## SUMMARY OF CONCERNS IN RELATION TO THE PROPOSED NORTHCONNEX TUNNEL

**This is an objection to many aspects of the proposed NorthConnex tunnel.**

Figure 5-17 Motorway operations complex

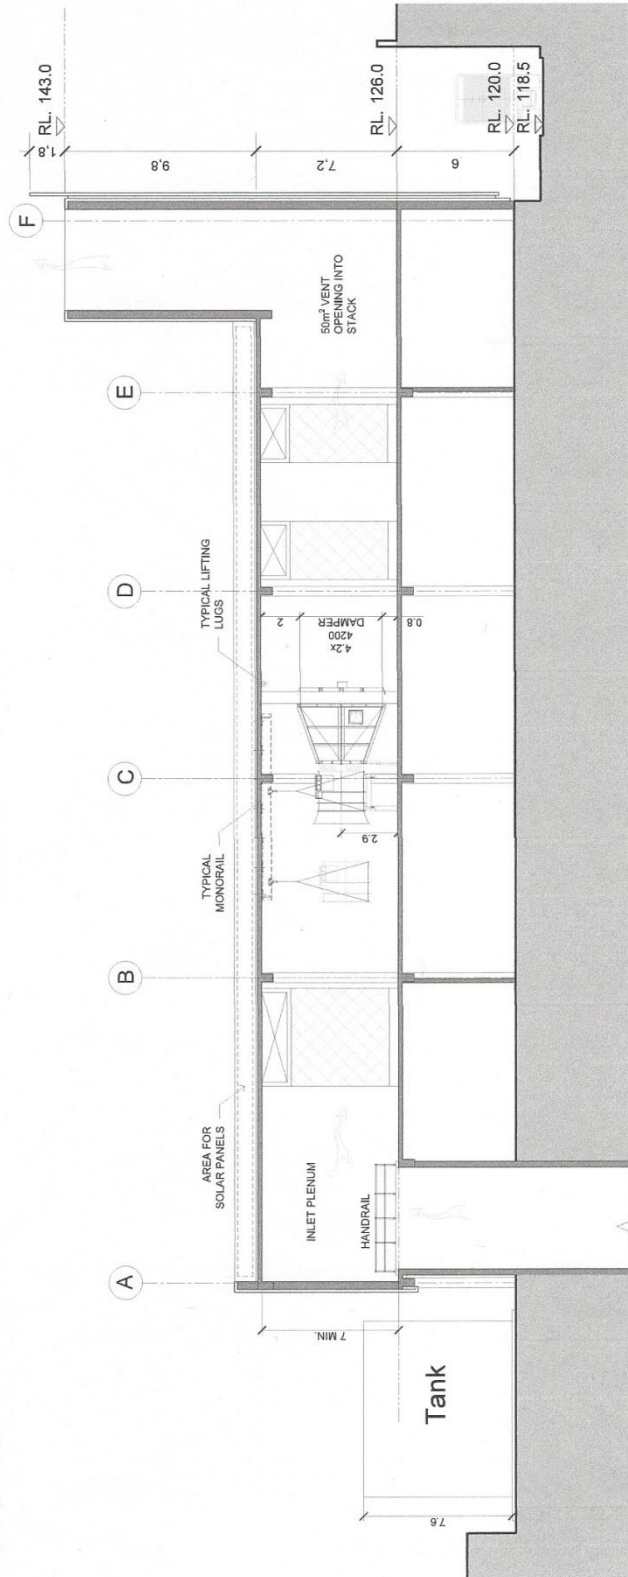
EIS Page 111, *Figure 5-17 Motorway operations complex*

*Page 8 below* there is no indication of how the ventilation facility will be connected to either the northbound or southbound tunnel, nor is there any indication of how the southbound exit portal onto Pennant Hills Road or the south-west exit portal onto the M2 will be connected.

- Diagrams need to be provided showing the inter-relation between the shaft, the ventilation outlet and the motorway operations centre with a clear description of what is to be constructed and how it will operate.
- The community needs irrefutable evidence that the polluted air from the southbound tunnel exit portals will not be allowed to flow like an invisible sewer through West Pennant Hills, North Rocks, Carlingford and Beecroft.

MOTORWAY OPERATIONS COMPLEX - SOUTHERN VENTILATION FACILITY - SECTIONS  
M1-M2-5000-DR-JD-0525

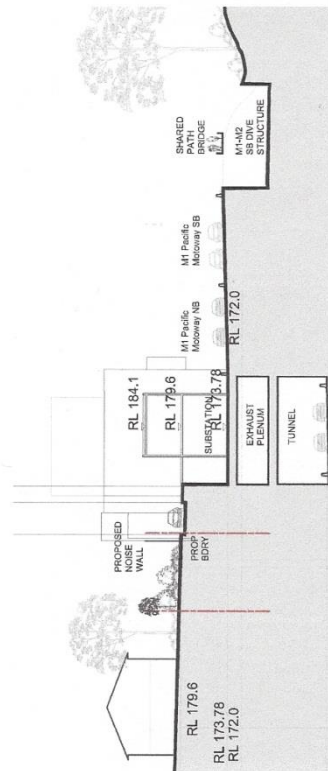
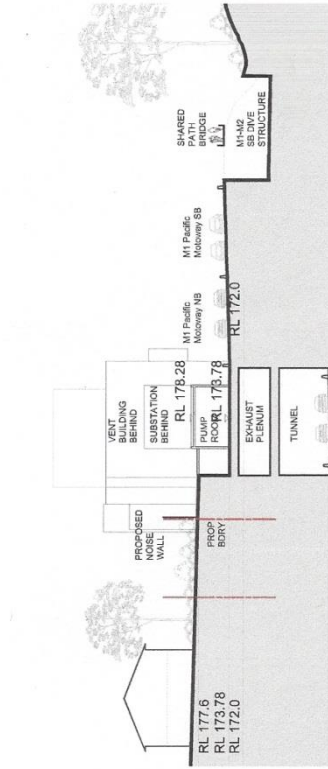
5. *EIS Volume 4, Technical working papers - Urban Design, 6.0 Operational Ancillary Facilities*  
EIS Page 99 there is the diagram "Motorway Operations Complex – Southern Ventilation Facility – sections. *Page 10 below* The diagram has the cryptic label "Connection to tunnel TBC". What does TBC stand for? To be considered? Why is tunnel singular? Which tunnel is the diagram referring to northbound or southbound? There is no diagram showing any connection from the Southern Interchange ventilation facility to either the northbound or the southbound tunnel in any way  
AND YET ....

MOTORWAY OPERATIONS COMPLEX - SOUTHERN VENTILATION FACILITY - SITE SECTION 1-1  
M1-M2-5000-DR-UD-0713

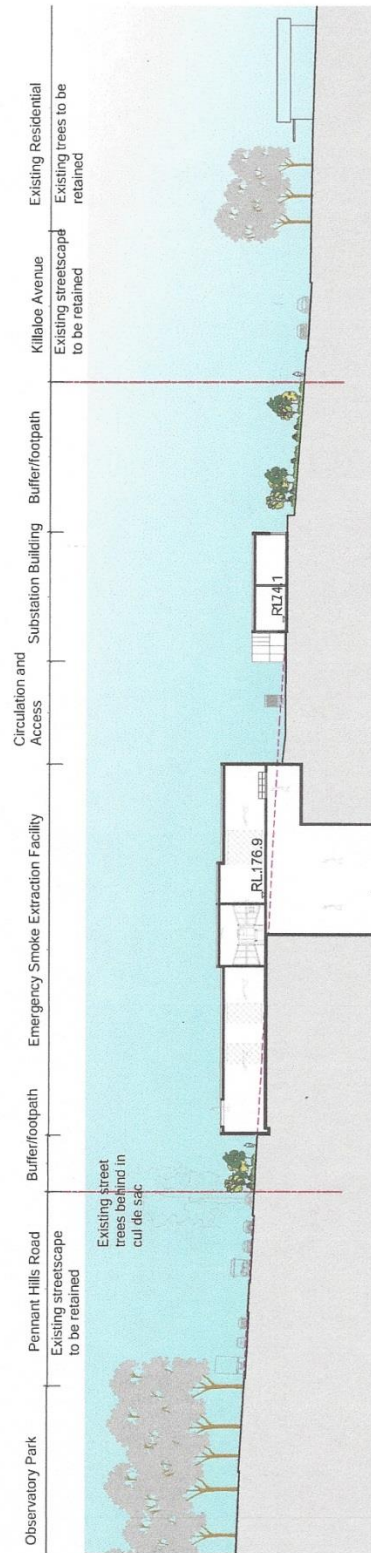
6. *EIS Volume 4, Technical working papers Urban Design, 8.0 Landscape Design*  
EIS Page 176 is the diagram "Motorway Operations Complex – Southern Ventilation Facility – Site 1-1". *Page 13 below* The diagram does not show any connection to either the northbound or southbound tunnel. In the same Landscape Design section, EIS Page 182 is the diagram "Wilson Road Tunnel Support Facility –Section" *Page 14 below* which clearly shows the connection to the tunnels. In the same Landscape Design section, EIS Page 189 is the diagram "Northern Ventilation Facility – Landscape Concept Section". *Page 15 below* This also clearly shows the connection to the tunnels.
